Subject: Issuance of Amendment No. 46 to Facility Operating License
NPF-9 and Amendment No. 27 to Facility Operating License
NPF-17 - McGuire Nuclear Station, Units 1 and 2

The amendments change the Technical Specification surveillance requirements related to the inservice inspection program for snubbers. The amendments are effective as of their dates of issuance.

AMENDMENT NO. 46 TO FACILITY OPERATING LICENSE NPF-9 - McGUIRE NUCLEAR STATION, UNIT 1
AMENDMENT NO. 27 TO FACILITY OPERATING LICENSE NPF-17 - McGUIRE NUCLEAR STATION, UNIT 2

SAFETY EVALUATION REPORT

FIGURE 4.7-1
SAMPLE PLAN 2) FOR SNUBBER FUNCTIONAL TEST

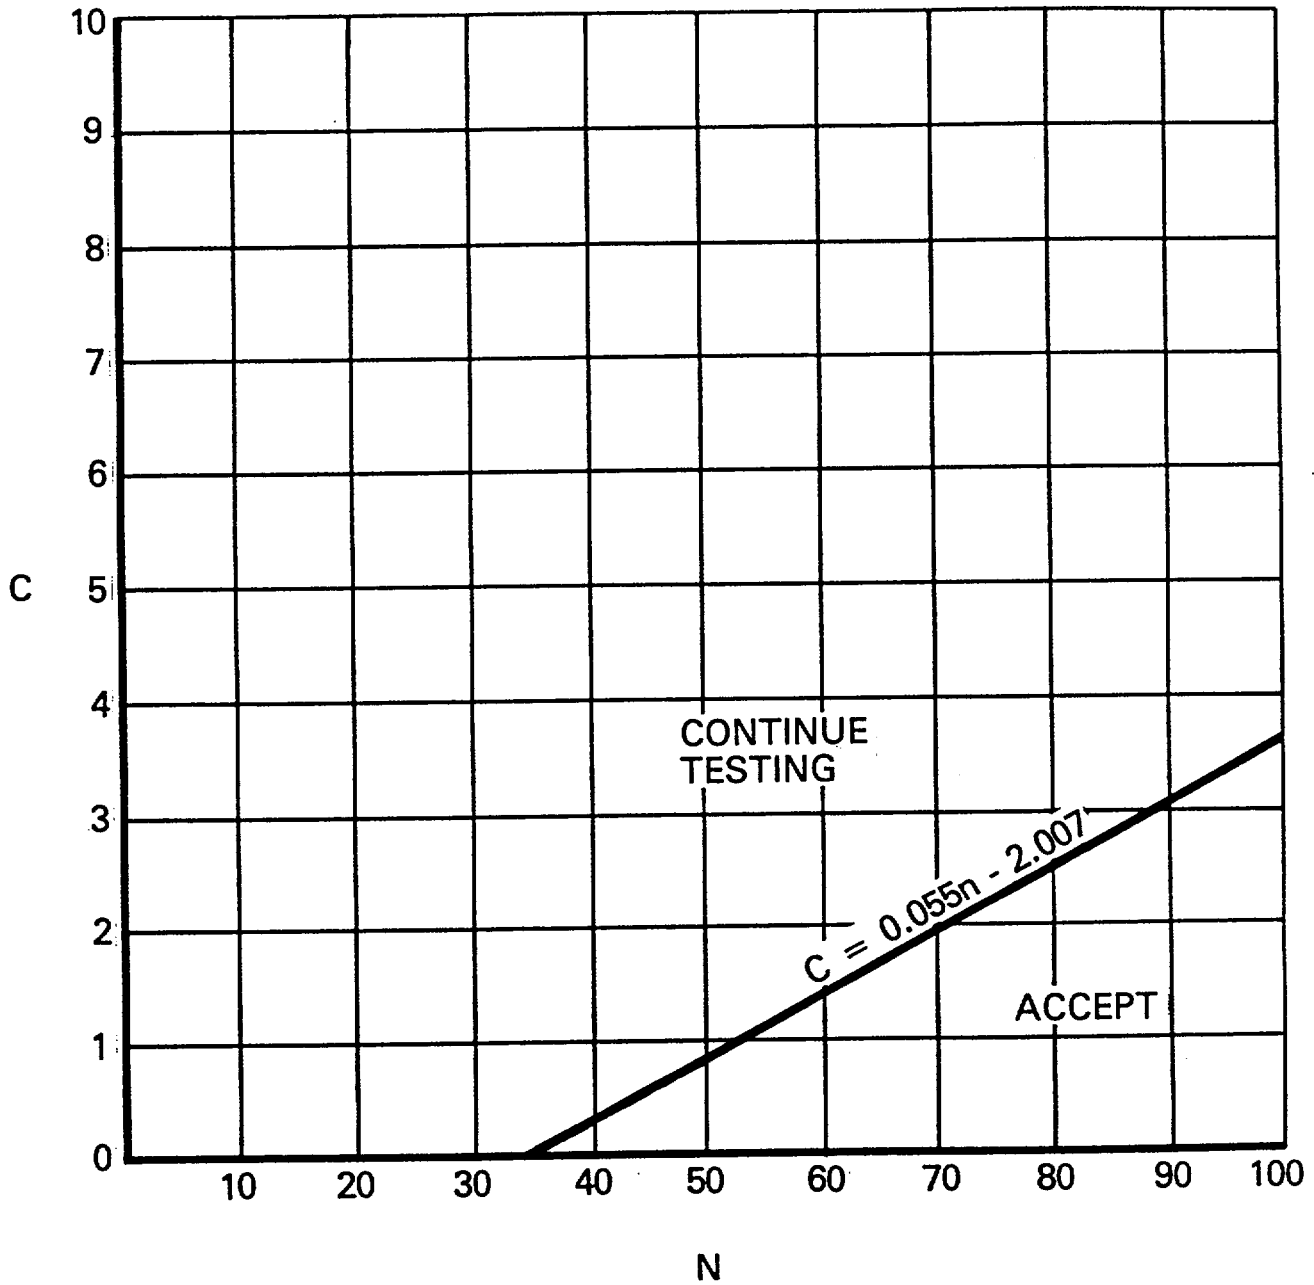
By letter dated April 9, 1985, Duke Power Company (the licensee) requested changes to a Technical Specification surveillance requirement which is part of an augmented inservice inspection program for snubbers. The change affects the second of three sampling plan options available for functional tests of snubbers. This second sampling plan is defined by Specification 4.7.8.e(2) and requires that a representative sample of snubbers be tested each refueling in accordance with Specification Figure 4.7-1. Figure 4.7-1 provides the acceptance criteria method for the functional test results and denotes a "reject" region and a "continue testing" region. If at any time the plotted test results fall within this "reject" region, then all snubbers are to be functionally tested. Surveillance requirement 4.7.8.e(2) and its accompanying Figure 4.7-1 are being changed to delete the "reject" region on Figure 4.7-1, to substitute an expanded "continue testing" region, and to clarify the manner in which test results should be plotted sequentially in the order of sample assignment (i.e., each snubber should be plotted by its order in the random sample assignment, not by the order of testing). References to the "reject" region in the text of Specification 4.7.8.e(2) and bases 3/4.7.8 are being deleted. Bases 3/4.7.8 is also supplemented by a footnote to note that if testing continues to between 100-200 snubbers (or 1-2 weeks) and still the "accept" region of Figure 4.7-1 has not been reached, then the actual percent of population quality (the ratio of total number of failed snubbers to the cumulative number of snubbers tested) should be used to prepare for extended or 100% testing.

Under Specification 4.7.8.e(2), a representative sample of snubbers, beginning with an initial selection of at least 37 snubbers, is functionally tested in accordance with a graph (Specification Figure 4.7-1) of "C", the total number of snubbers found not meeting the acceptance requirements of Specification 4.7.8f (i.e., failures), versus "N", the cumulative number of snubbers tested. The existing graph denotes three separate regions designated "accept," "continue testing" and "reject." The "accept" and "continue testing" regions are separated

by a curve, $C = 0.055N - 2.007$; the "continue testing" and "reject" regions are presently separated by a curve, $C = 0.055N + 2.007$. To apply the graph, test results are plotted on Figure 4.7-1. Under the existing Technical Specifications, if at any time the point plotted falls in the "reject" region all snubbers are to be functionally tested. If at any time the point plotted falls in the "accept" region, testing of snubbers may be terminated. When the point plotted lies in the "continue testing" region, additional snubbers are to be tested until the point falls in the "accept" region or the "reject" region, or all the required snubbers have been tested. Deletion of the "reject" region, as implemented by this amendment, effectively changes that region of the graph to a "continue testing" region. Therefore, snubbers will continue to be tested until the plotted point falls in the "accept" region or until all the safety-related snubbers have been tested.

Statistical studies within the licensee's submittal of April 9, 1985, and within a draft document by a task force of the Operations and Maintenance Group (OM-4) of the ASME Committee, "Examination and Performance Testing of Nuclear Power Plant Dynamic Restraints (Snubbers)" (ANSI/ASME OM4-1985) demonstrate that the proposed deletion of the "reject" region does not have a significant adverse effect on the effectiveness of the sampling plan. These statistical studies indicate that while the probability of false acceptance of a bad population under the proposed amendments is real, it is negligible. The Commission's review of these documents supports this conclusion. We also find that the revised plotting sequence is a more appropriate method for implementing the sampling plan. Therefore, the staff finds the proposed changes to be acceptable.
